Subject: Implementing ultra-precision flat carrier tape and heat activated cover tape

PCN #: PCN-01340

PCN Number: PCN-01340		PCN Date: May 29, 2019	
Title: Tape and reel carrier tape change			
Proposed first Ship Date: June 2020		Estimated Sample Availability/Qualification Completion:	On request
Proposed last Ship Date:			
Change Classification: Major ☐		Minor ☒	
Change Type:			
Assembly Site ☒	Design ☐	Electrical Specification ☐	
Test Site ☐	Assembly Process ☐	Mechanical Specification ☐	
Test Process ☐	Assembly Materials ☐	Packing/Shipping/Labeling ☒	
PCN Details			
Description of Change:			
The carrier tape is being converted from raised channel to an ultra-precision flat pocket with tighter tolerances. In addition, the cover tape will change From Pressure Seal (PSA) 3M 2668 to Pressure Seal (PSA) 3M 2698. Dimensions and shape for carrier tape changes are shown below. From:

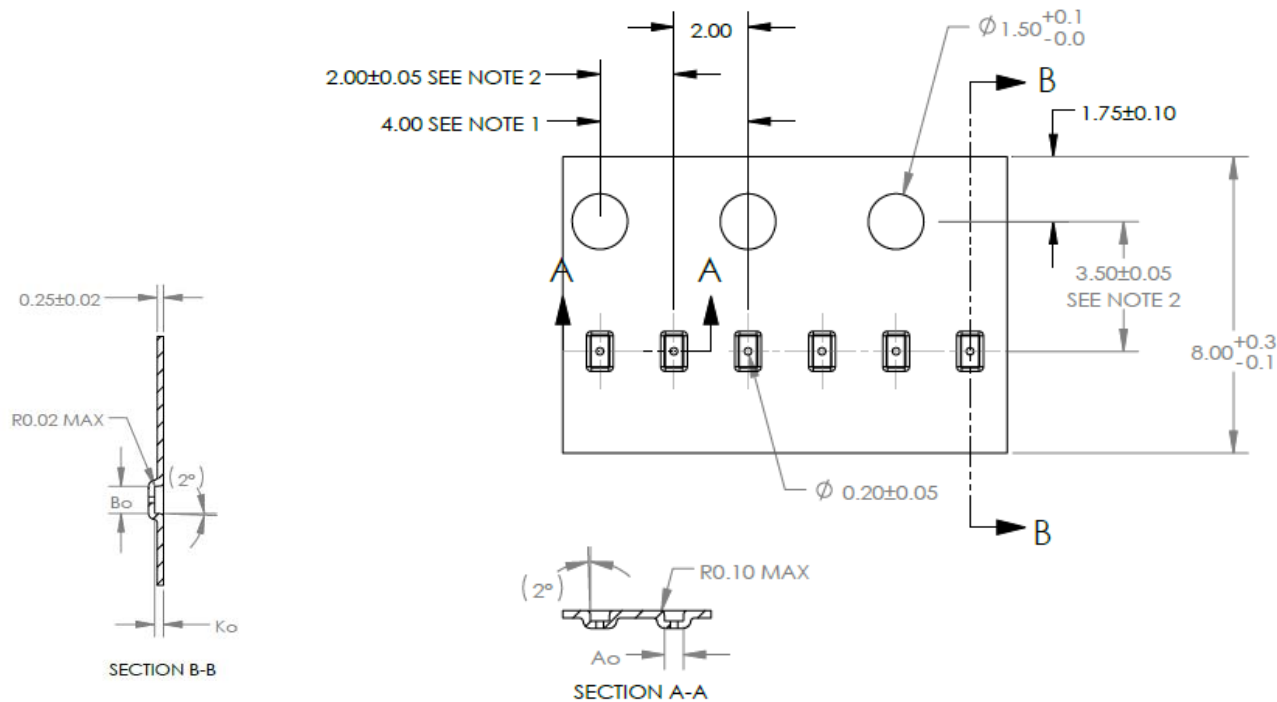
To:

DIM	$\pm$
A ϕ	0.51	0.03
B ϕ	0.87	0.03
K ϕ	0.28	0.03

Minimize the die out of pocket and the die sticking to cover tape due to mechanical adhesion and for ease of assembly.
